**Door Lock Mechanism – Tight
Operation – Modification Procedure**MODEL 1995-96 MY
Sedan Range

720001-ON

ILLUSTRATION 1

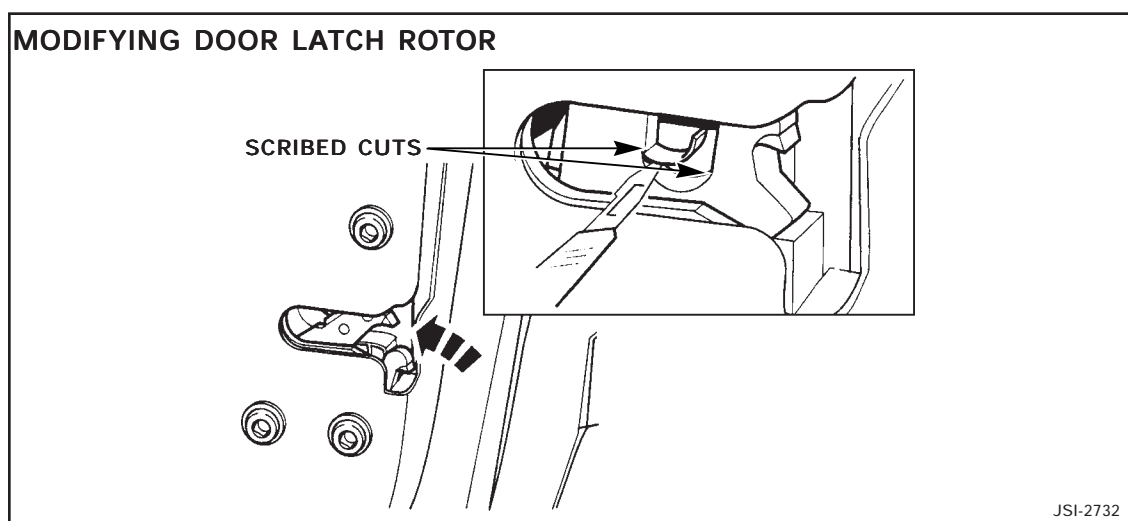
Some 1995 MY-ON Sedan Range vehicles may exhibit tight operation of the door lock mechanism. This condition has been found to be caused by the plastic coating on the latch rotor.

1. Use a screwdriver to move the latch rotor into a partially closed position as shown in Illustration 1.
2. Refer to Illustration 1 and use a sharp knife to scribe two cuts across the width of the latch rotor at each end of the curved portion.

3. Cut away and remove (in one piece, if possible) the curved portion of the plastic coating between the two scribed cuts (Illustration 1). Plastic should only be removed from the curved area of the latch rotor, not on the straight sections. Do not allow the removed pieces to drop into the lock mechanism.

CAUTION: Do not use hand files, rotary grinders or similar tools for this operation, since debris can fall into the lock.

4. Lift the outer door handle and push the latch rotor to the fully open position.
5. Check the operation of the door latch to verify improved operation.
